**UN Regulation No. 67 (LPG vehicles)**  
Draft proposal for Supplement 15 to the 01 series of amendments

**Arrangement of the LPG equipment type approval mark**

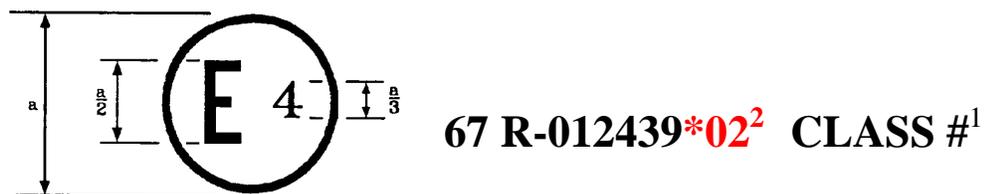
*Annex 2A, amend to read:*

The above approval mark affixed to the LPG equipment shows that this equipment has been approved in the Netherlands (E 4), pursuant to Regulation No. 67 under approval number 012439, **second extension of type-approval**. The first two digits of the approval number indicate that the approval was granted in accordance with the requirements of Regulation No. 67 as amended by the 01 series of amendments. **The number of extension (02 in the example) is preceded by an asterix.**
